[Docket No. 99-SW-34-AD; Amendment 39-11732; AD 2000-10-08]

Airworthiness Directives; Eurocopter France Model SA-365N1, AS-365N2, and SA-366G1 Helicopters

AD 2000-10-08 Eurocopter France:

Amendment 39-11732. Docket No. 99-SW-34-AD.

FIGURE 1

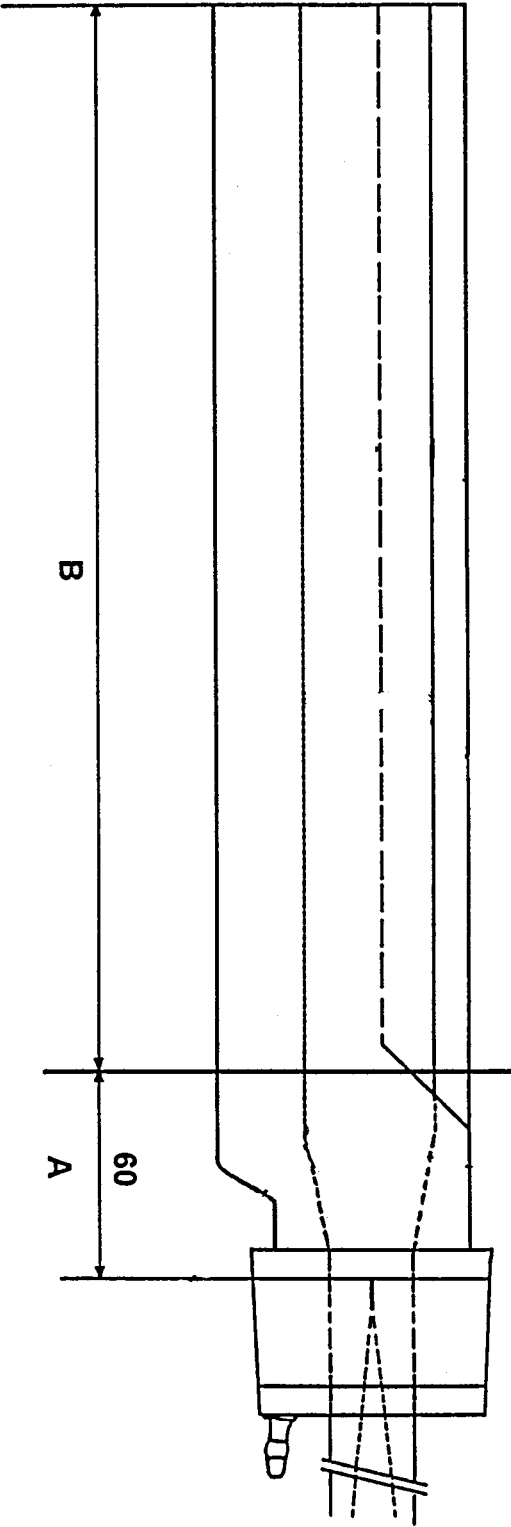
(a) Within 10 hours time-in-service (TIS) and thereafter prior to the first flight of each day, conduct the following visual inspection of each blade (see Figure 1):

(1) Zone A: If a blister is detected on the blade suction face, conduct a tapping test inspection on the whole blade for bonding separation. If bonding separation or a crack is found, replace the blade with an airworthy blade before further flight.

(2) Zone B: If a crack, wrinkling, or a blister is found, replace the blade with an airworthy blade before further flight.

(e) Within 10 hours TIS, and thereafter at intervals not to exceed 100 hours TIS or 200 cycles, whichever occurs first, measure the blade-to-air duct clearance. If the clearance is less than 3 mm, replace the blade with an airworthy blade before further flight.
